HOLDOVER
REVISED
GOLDEN POND SUBDIVISION

APPLICATION NUMBER Holdover DATE May 15, 2003
APPLICANT Golden Pond Subdivision
REQUEST Subdivision

GOLDEN POND SUBDIVISION

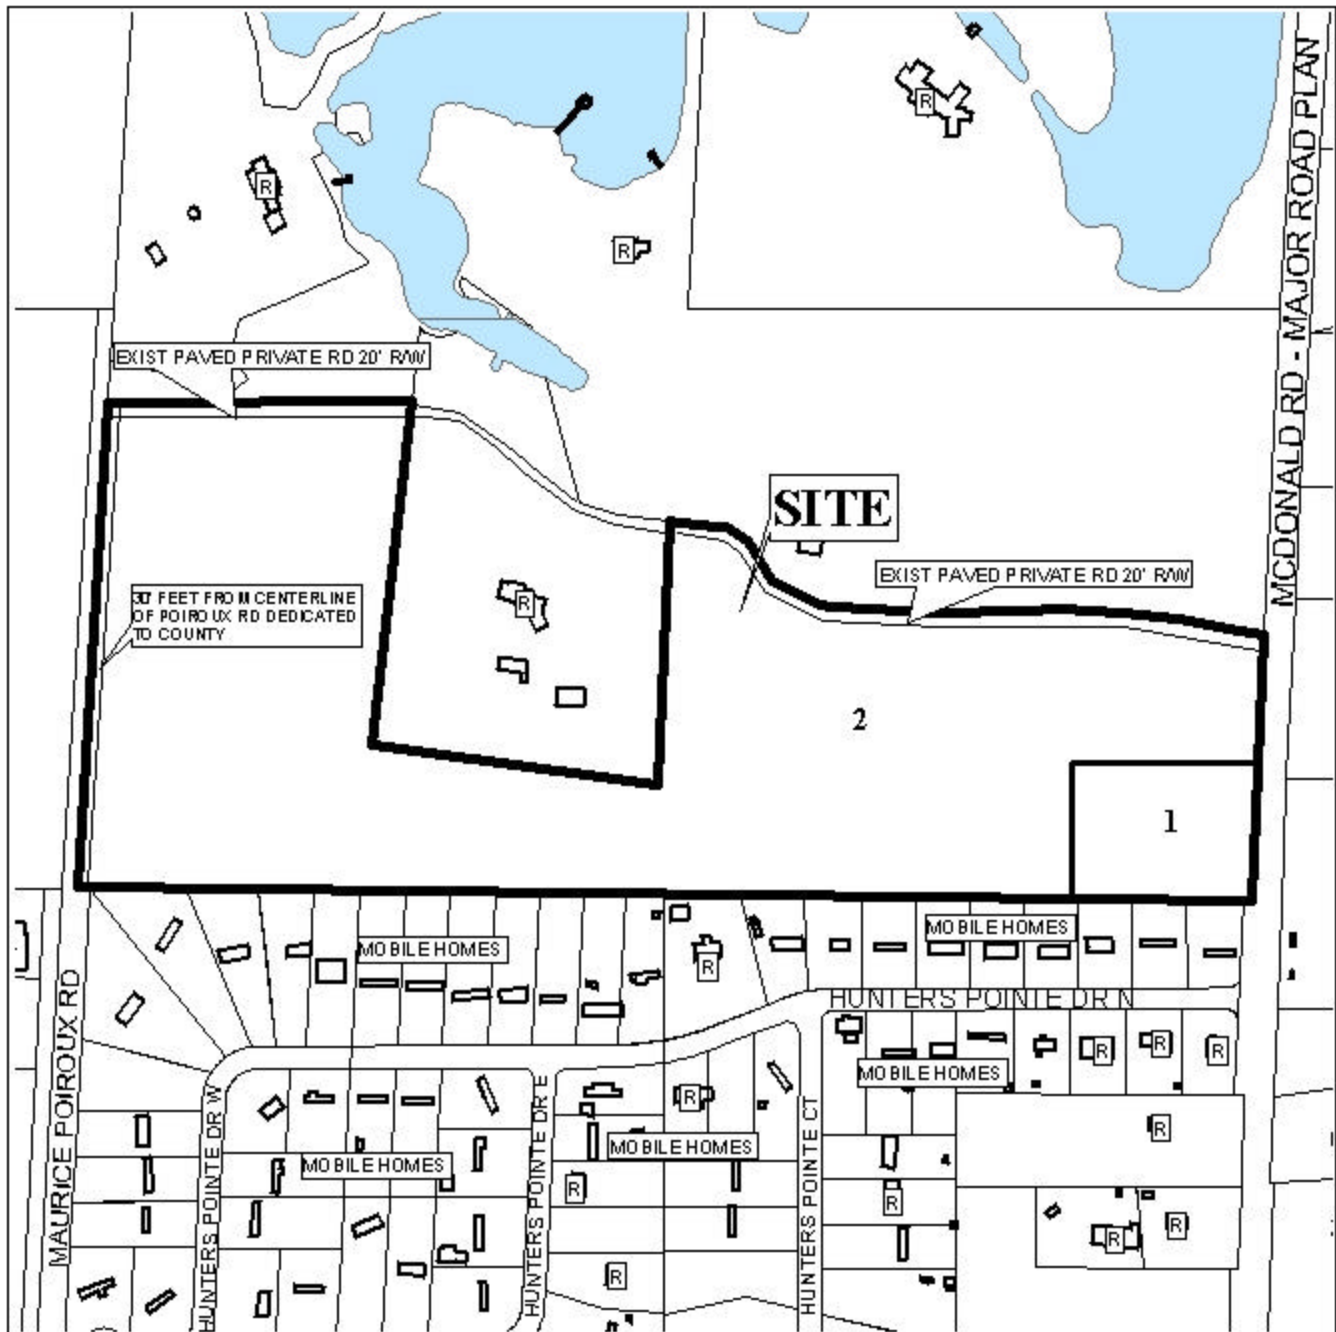
The twenty-five foot minimum building setback line is not shown but would be required on the final plat.

County Engineering notified the Land Use Department that the portion of Maurice Poiroux Road adjoining the site is not maintained by the County. The applicant has submitted a revised plat for a two-lot subdivision with Lot 2 having frontage on McDonald Road. Because Lot 2 also fronts the unopened portion of Maurice Poiroux Road, Lot 2 should be denied direct access to Maurice Poiroux Road until it is constructed to County standards.

*The plat meets the minimum requirements of the Subdivision Regulations and is recommended for Tentative Approval for a **two-lot** subdivision subject to the following conditions: 1) the dedication of sufficient right-of-way to provide 50-feet from the centerline of McDonald Road; 2) the dedication of sufficient right-of-way to provide 30-feet from the centerline of Maurice Poiroux Road; 3) the placement of a note on the final plat stating that if the property is developed commercially and adjoins residential property, a buffer, in compliance with Section V.A.7. of the Subdivision Regulations will be provided; 4) the placement of note on the final plat stating that Lot 2 is denied direct access to Maurice Poiroux Road until it is constructed to county standards; and 5) the placement of the twenty-five foot minimum building setback line on the final plat.*
